Appendix B (i)

Town Centre Masterplan Framework – Schedule of summary of representations received

Figure 2: Extract from Submitted Design Code supporting Outline Application
Layout

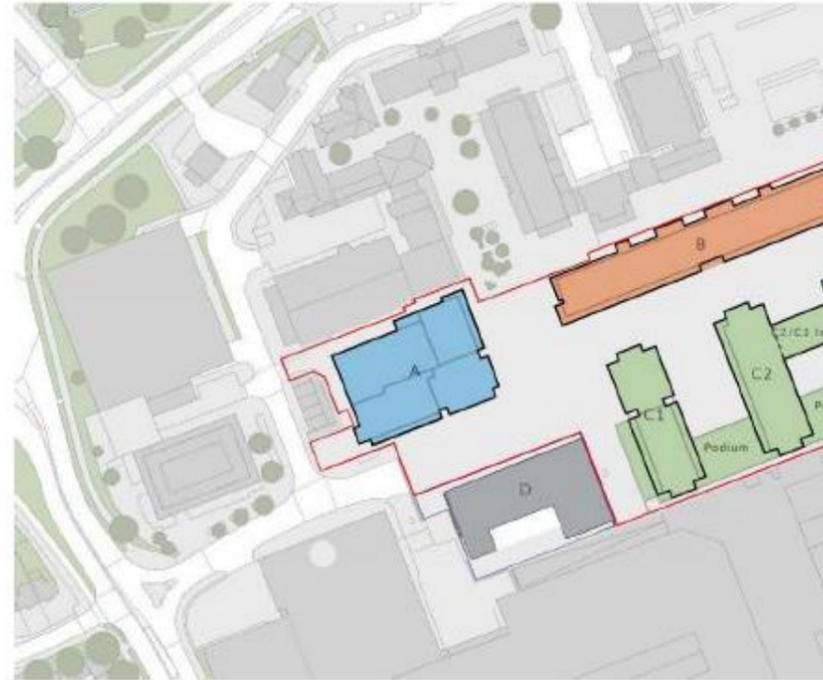
For consistency, the Outline scheme continues with the same naming of the development blocks as A, B, C and D (as identified in Figure 2). In the proposals, Block B can be subdivided into B1

and B2 and Block C can be subdivided into Block C1, C2 and C3. The indicative layout of the outline proposal for Blocks A-C, as well as the location of the consented Block D, is shown below at Figure 3.	
--	--	--	--	--
